SPECIALIST STUDY: NOISE IMPACT ASSESSMENT: PROPOSED GREAT KAROO WIND ENERGY FACILITY NEAR SUTHERLAND: CHANGE OF WIND TURBINE LAYOUT AND SPECIFICATIONS

The above-mentioned issue as well as report ACED-HV/NIS/201202-Rev 0 is of relevance.

Figure 1: Previous and new locations of the wind turbines for the proposed wind farm

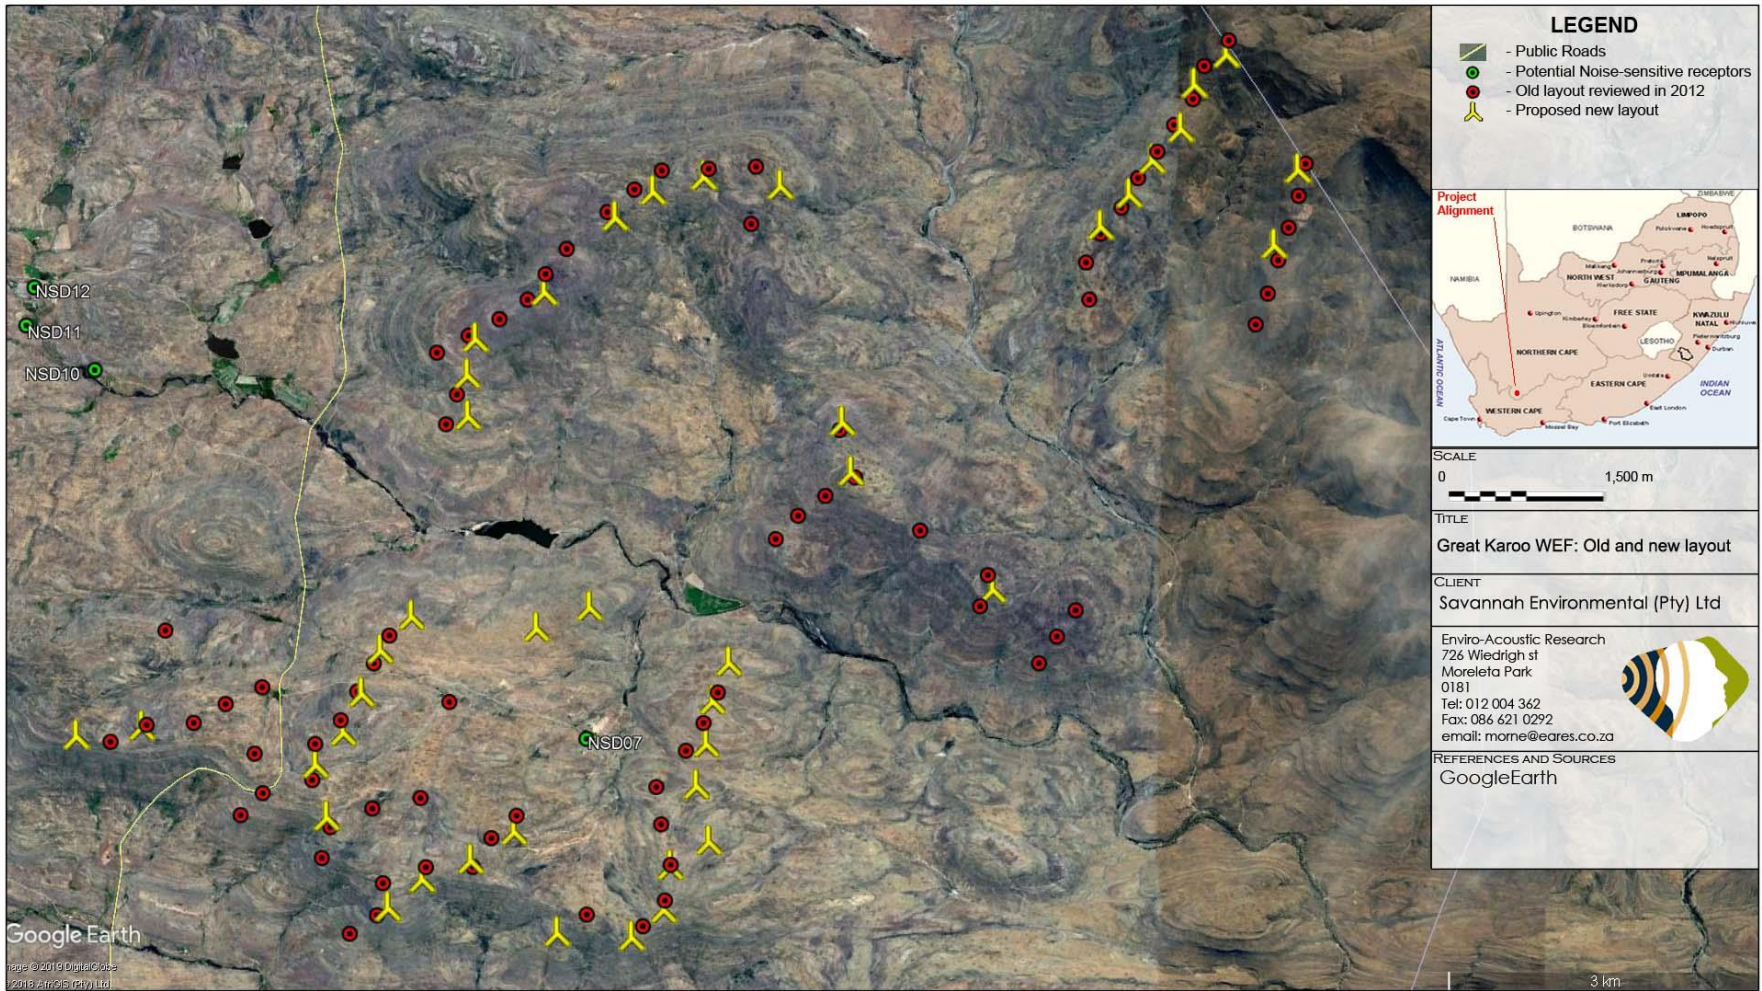
The updated layout locates the closest WTG 1,090m from NSD07, with eight WTG located within 1,500m from this NSD. The wind turbines (of the new layout) are on average slightly further from this potential noise sensitive receptor.

Considering the location of the wind turbines and the potential noise impact, it is my opinion that the change will not increase the significance of the noise impact, subject that a wind turbine with a maximum sound power emission level of 107 dBA are used by the developer. A full noise impact assessment with new modeling will not be required and the recommendations as contained in the previous document will still be valid.

If the developer selects a wind turbine generator with a sound power emission level exceeding 107 dBA, the noise impact assessment must be reviewed in detail.
